Approved Section 75W Modification Application

No. MP 10-0027 MOD1 granted on the 24 JULY 2012

Revision E - Section 75W Amendments

Site 3
Sydney Olympic Park
Plan
Basement 001

**Site 3
 Sydney Olympic Park
 Plan
 Level 24**

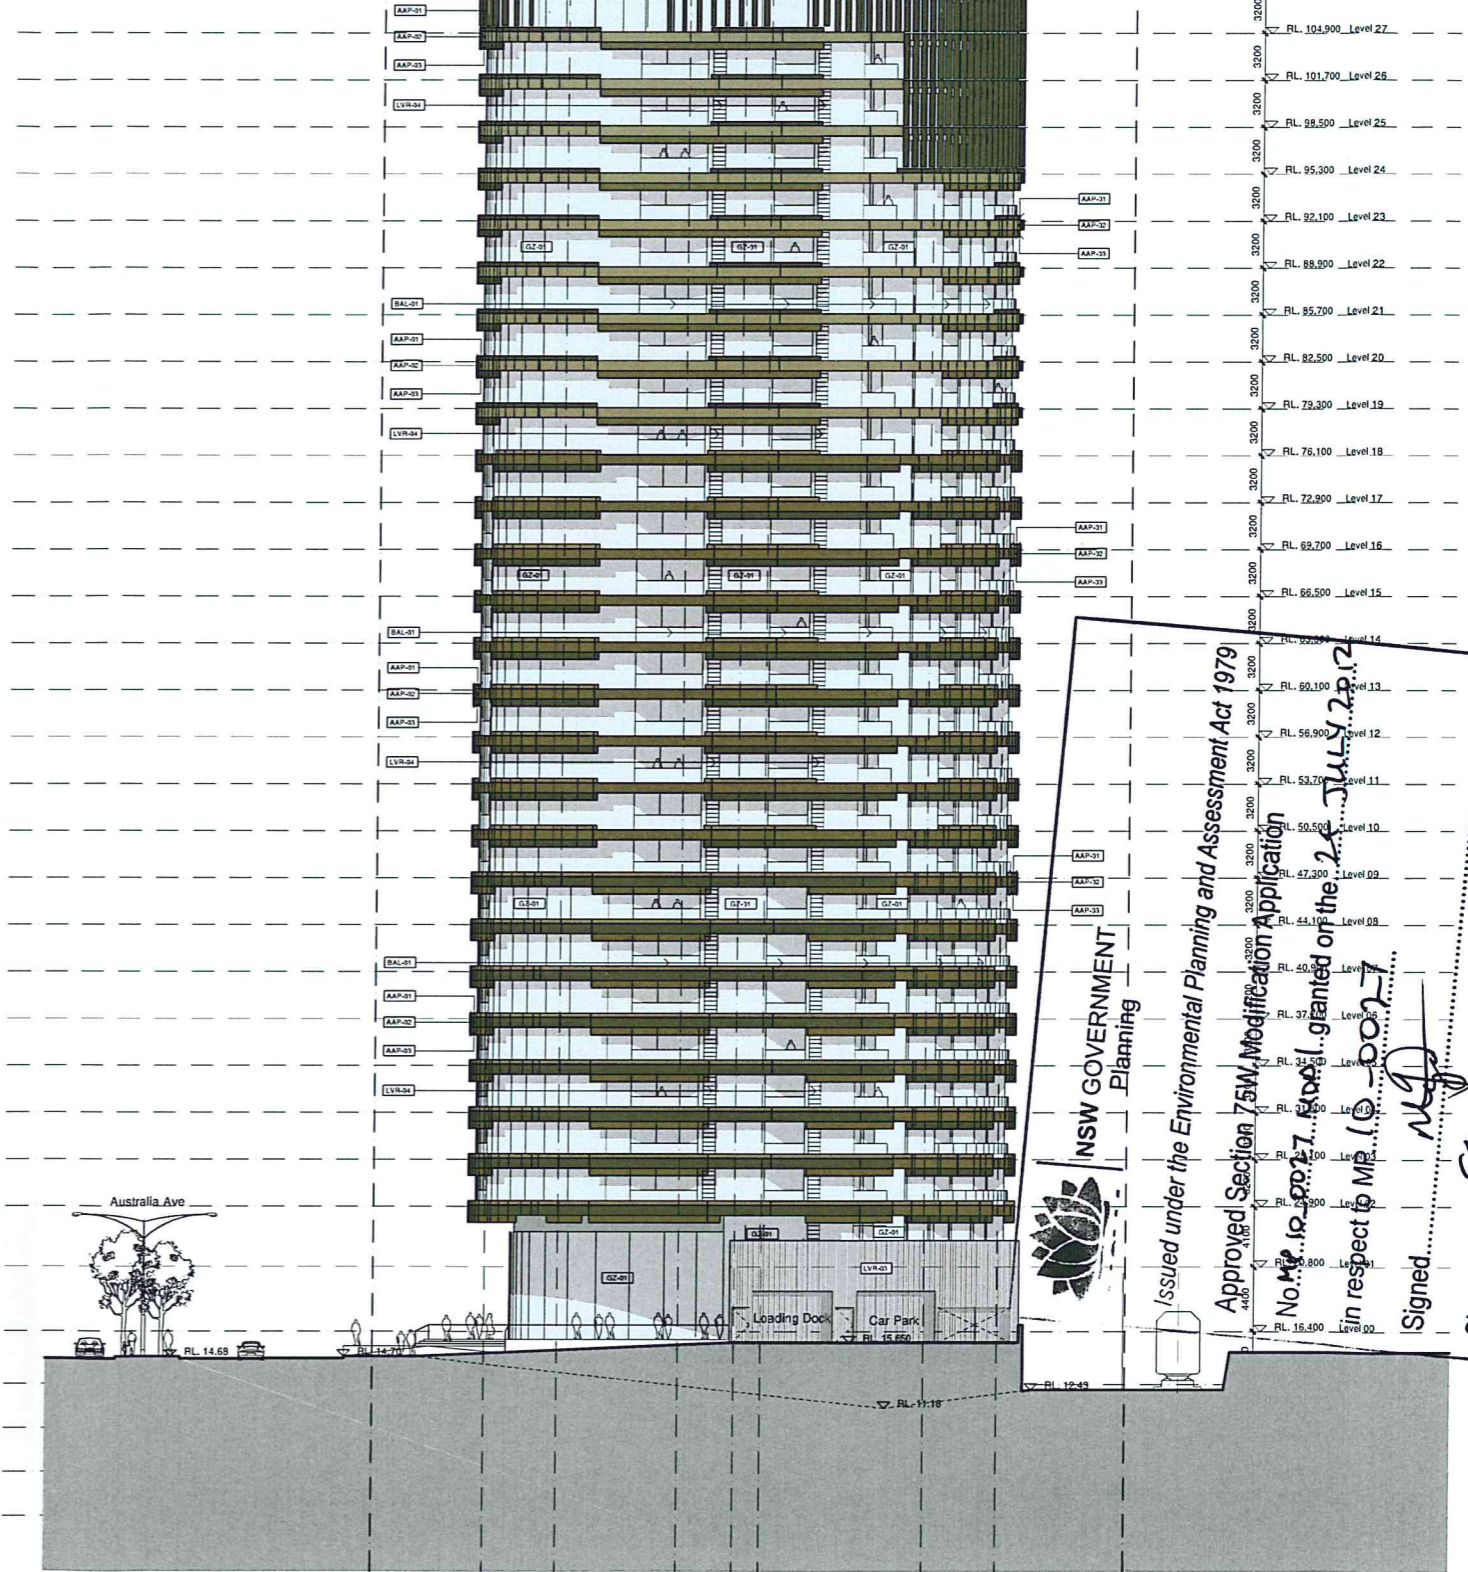
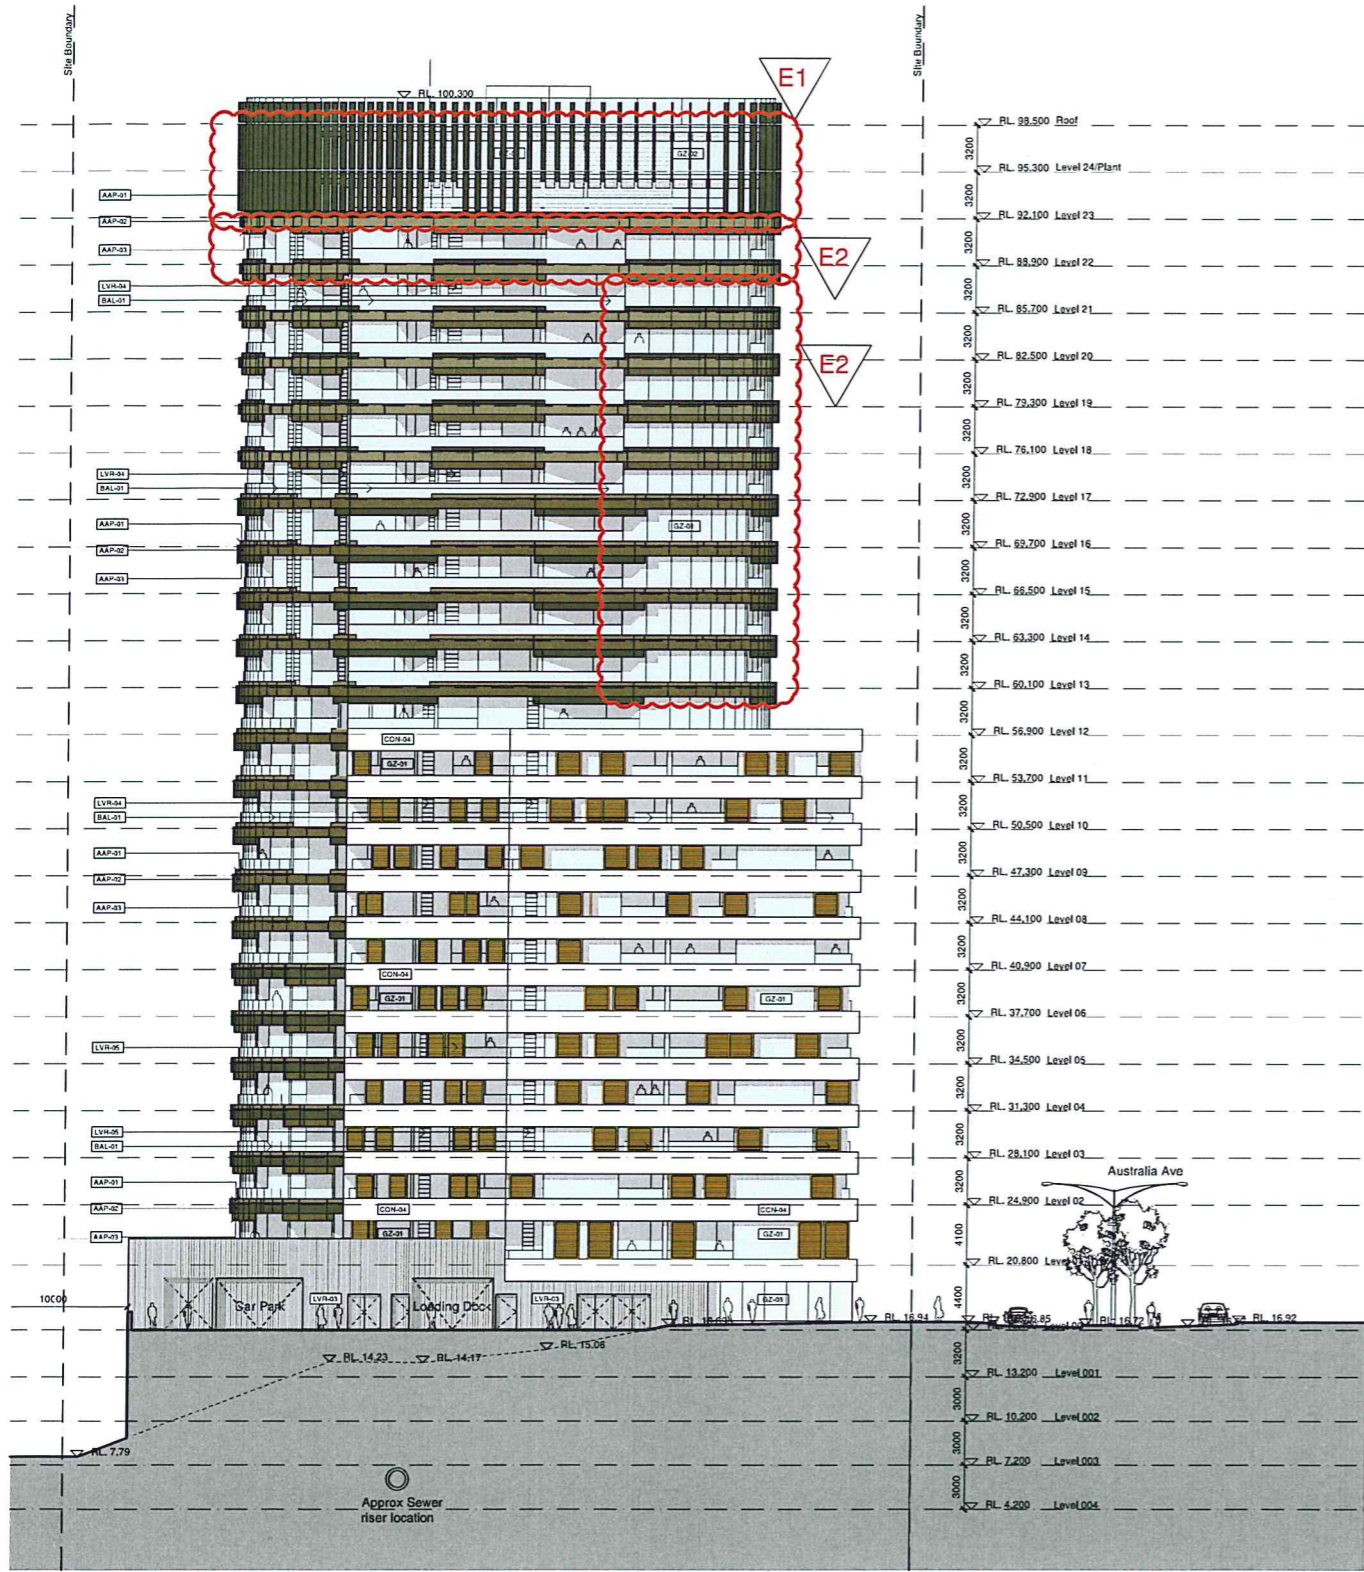
- Revision E - Section 75W Amendments**
1. One 3-Bed Lot (C25.01) has been modified to one 2-Bed single storey apartment (C25.01).
 2. One 3-Bed Lot (C25.03) has been modified to one 2-Bed single storey apartment (C25.03).
 3. One 2-Bed Lot and two 4-Bed Lots (C25.04, C25.05 & C25.06) have been modified to four 1-Bed single storey apartments (C25.04A, C25.04B, C25.05 & C25.06), including two units allocated as accessible units.
 4. One 3-Bed Lot (C25.07) has been modified to one 2-Bed single storey apartment (C25.07).
 5. Lift access has been extended to serve Level 24 apartments.
 6. Garbage room has been added to serve Level 24 apartments.

Site 3
Sydney Olympic Park
Elevation
North & South

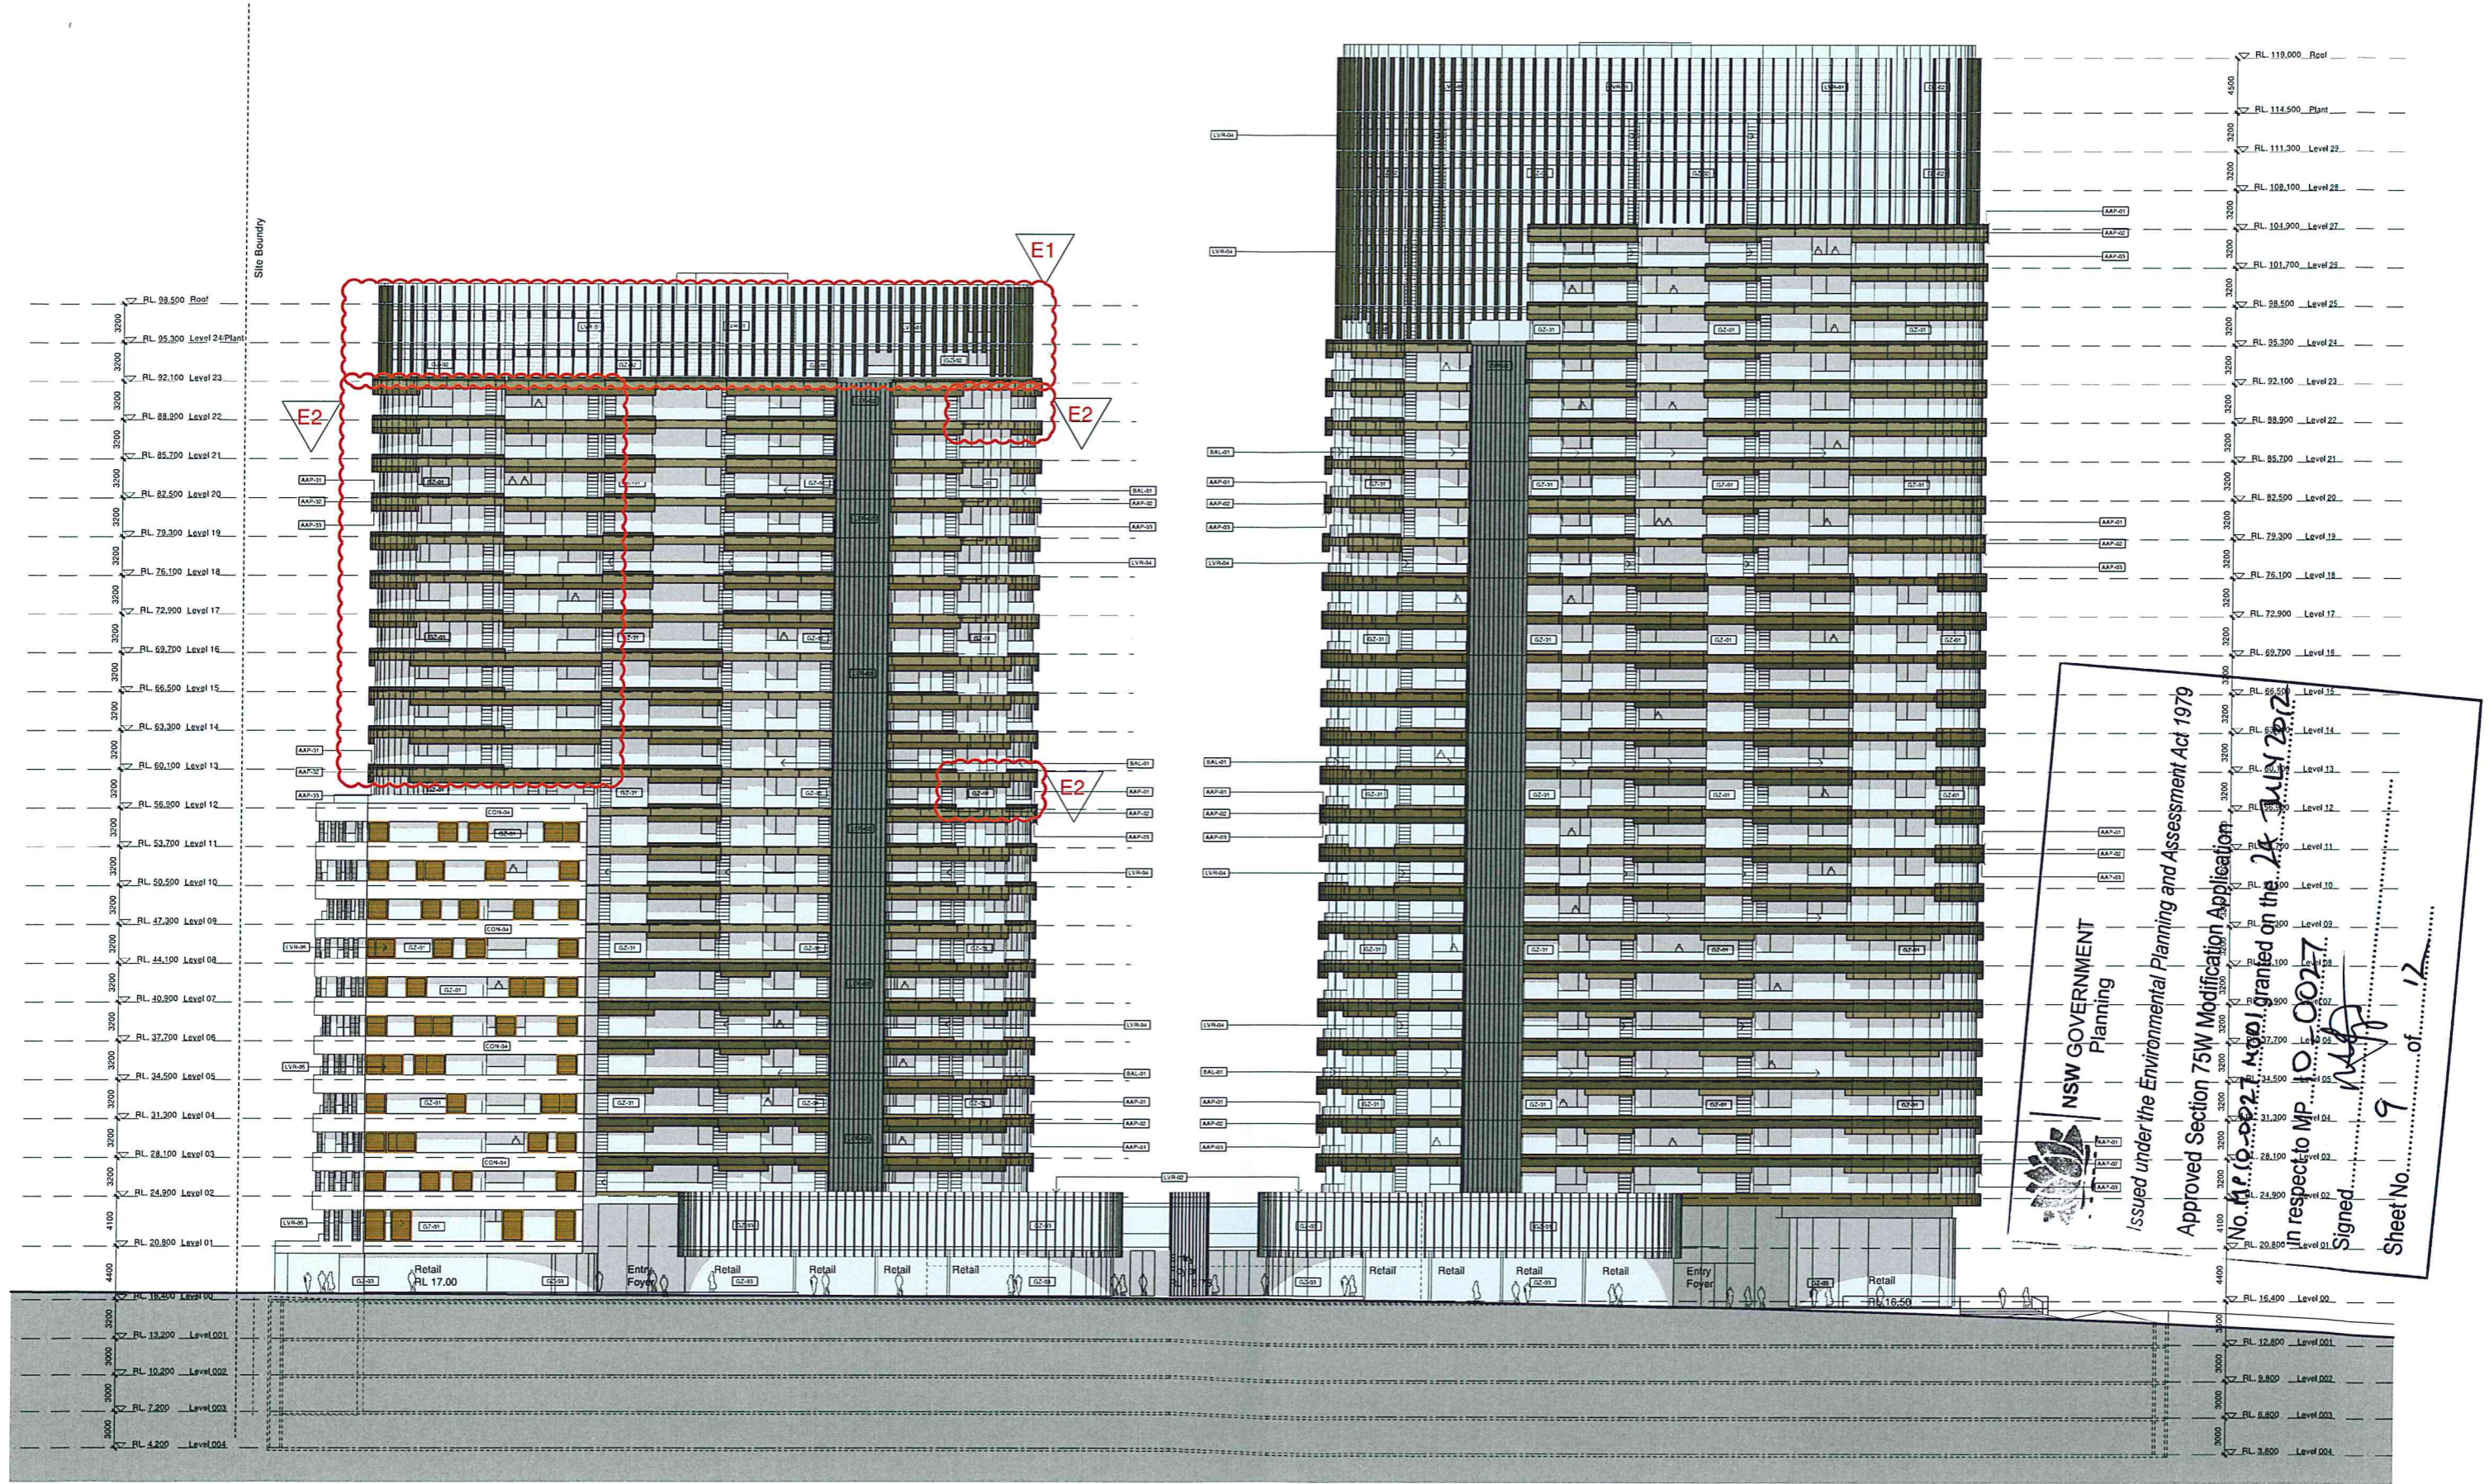
1. Lift apartments modified to single storey apartments on Level 23 & 24. Elevation amended to match current plans.
2. Elevation amended to match current plans.
